DSA CODE AMENDMENT DEVELOPMENT

The Division of the State Architect (DSA) has prepared initial drafts of proposed code amendments for the 2016 Intervening Code Adoption cycle. The draft of each amendment is presented with the current code language, the suggested text of the proposed amendment, the code text if adopted and a rationale for the proposed change. The code amendments are listed below and will be presented at Access Code Stakeholder Forum scheduled for October 20, 2016.

Index of Code Amendments

Figure 11B-404.2.4.3
Maneuvering Clearances at Recessed Doors and Gates

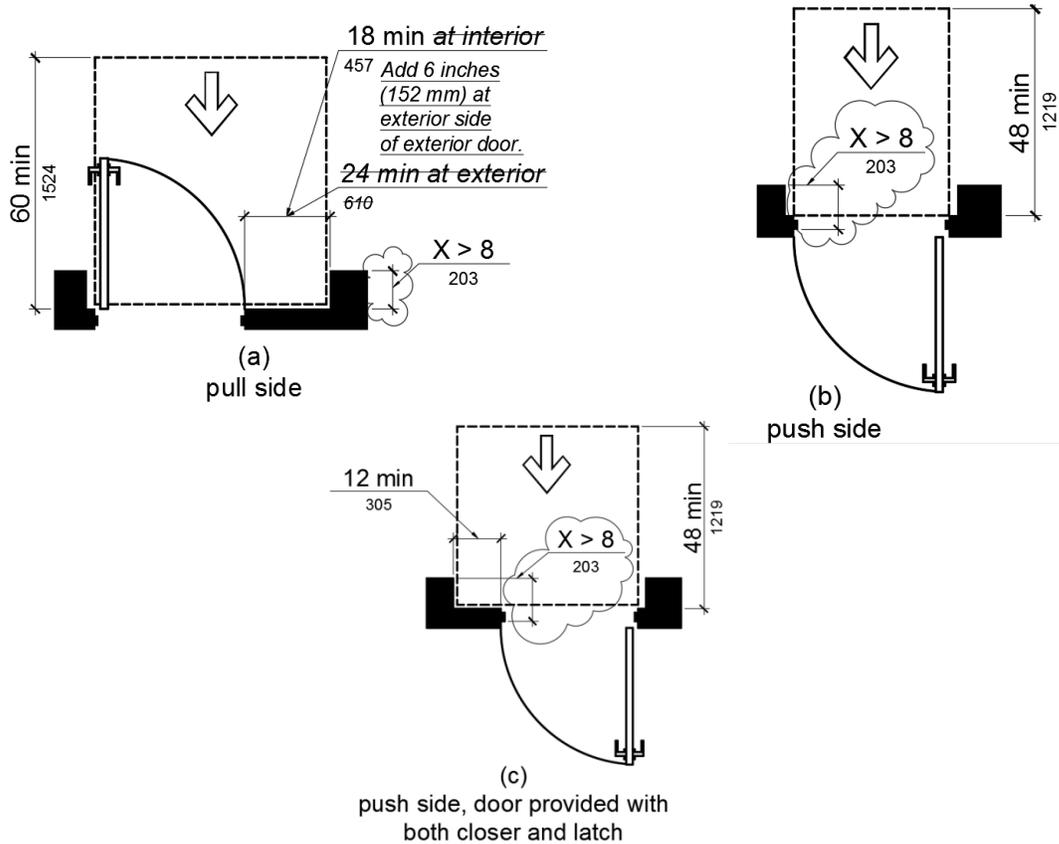
Applicable Code
Applicable Code Section(s): 11B-404.2.4.3, Figure 11B-404.2.4.3(a)
Topic: Maneuvering clearance at recessed doors and gates

CBC Section 11B-404.2.6 requires maneuvering clearance for forward approach when any obstruction within 24 inches of the latch side of an exterior doorway projects more than 8 inches beyond the face of the door; this requirement is illustrated in Figure 11B-404.2.4.3(a). However, the maneuvering clearance dimensions for the strike side clearance width are not consistent with Figure 11B-404.2.4.1(a) which illustrates the required maneuvering clearance for forward approach at an exterior door which is not recessed. DSA proposes to amend the latch side clearance width dimension in Figure 11B-404.2.4.3(a) to be consistent with Figure 11B-404.2.4.1(a); this dimension will read: "18 min" followed by "Add 6 inches (152 mm) at exterior side of exterior door."

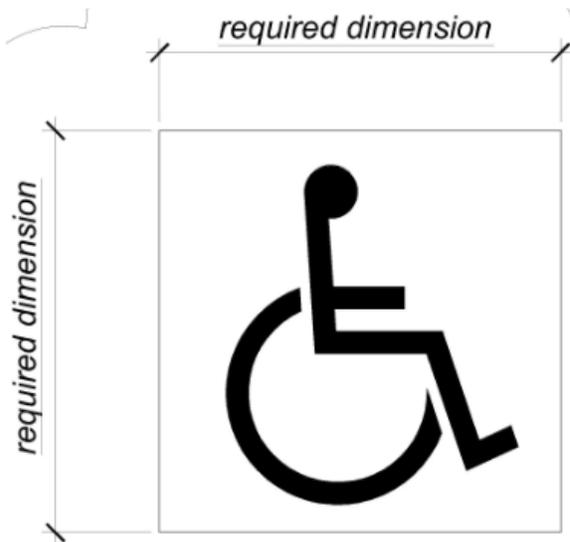
CBC Section 11B-502.6.4 requires an International Symbol of Accessibility (ISA) on the ground surface of standard accessible and van accessible parking spaces. DSA has received a number of questions about whether a border is required around the ISA; in response, DSA notes the text of the building code does not require a border around the ISA.

DSA is proposing to add permissive language which allows a border to be provided at the accessible parking ISA – either inside, at, or outside of the minimum required ISA dimension of 36" x 36".

11B-502.6.4.2 *The parking space shall be outlined or painted blue and shall be marked with an International Symbol of Accessibility complying with Section 11B-703.7.2.1 a minimum 36 inches wide by 36 inches high (914 mm by 914 mm) in white or a suitable contrasting color. A border may be provided inside, at, or outside of the minimum required ISA dimension. The centerline...*

**FIGURE 11B-604.7.2
DISPOSAL UNIT LOCATION**

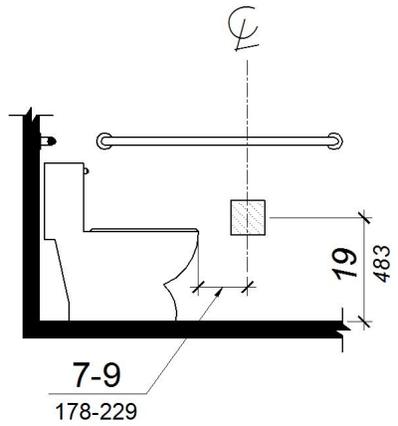
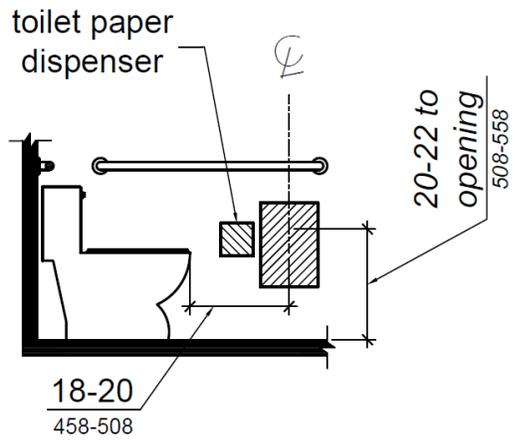
- The title of Figure 11B-604.7 will be changed to Figure 11B-604.7.1. Figure 11B-604.7.2 will be added to the California Building Code.

Figure 11B-703.7.2.1
International Symbol of Accessibility

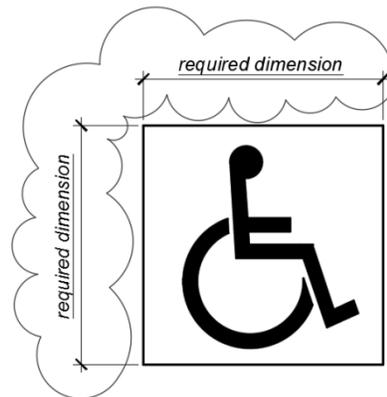
This amendment is proposed to provide code users with clarity for determining the dimension points when using the International Symbol of Accessibility.

Figure 11B-705.1
Size and Spacing of Truncated Domes

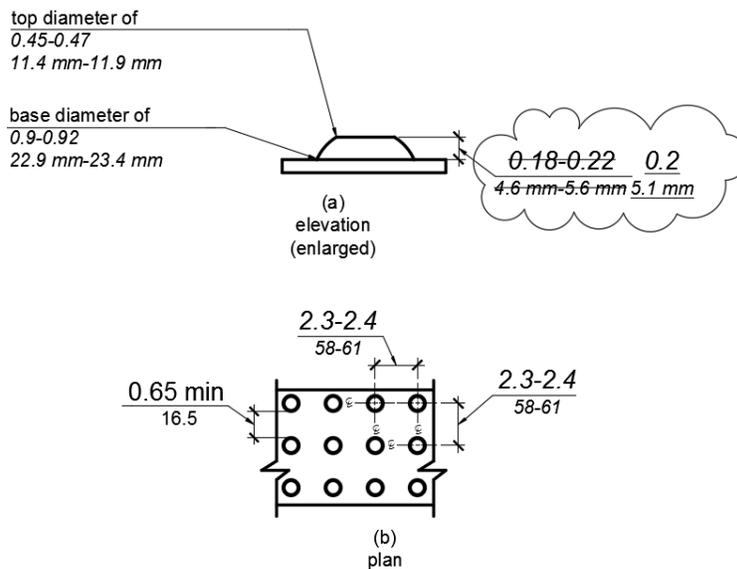
The revision occurs to the dimension in the figure for the height of the truncated domes. The proposed amendment will align the dimension in the figure to the code text that was amended during the rulemaking cycle for the 2016 triennial code.

- This revision is made in response to a comment from a code user who identified the discrepancy between the code text and the figure.
